ELECTRONIC CLIMATE CONTROL

SERVICE BULLETIN

To minimize large temperature swings in the motorhome.

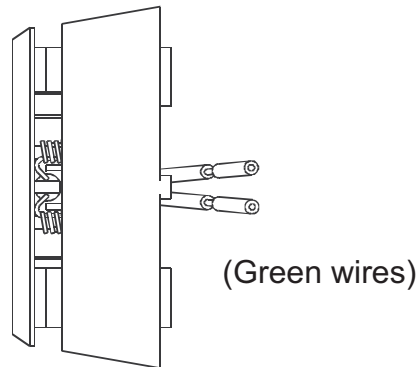
Old temp probe assembly
P/N 00-00356-000

New temp probe assembly
P/N 00-00356-100

This will move the temperature sensing device out of the wall and into the room.

- 1) Remove the two screws holding the old probe (00-00356-000) to the wall.
- 2) Pull assembly from the wall and cut both white wires.
***Leave enough wire for the connection of the new wires.**
- 3) Splice green wires from the new assembly (00-00356-100) together with the wires coming out of the wall. Polarity is NOT important.
- 4) Push wires back into wall and screw the new assembly into place.
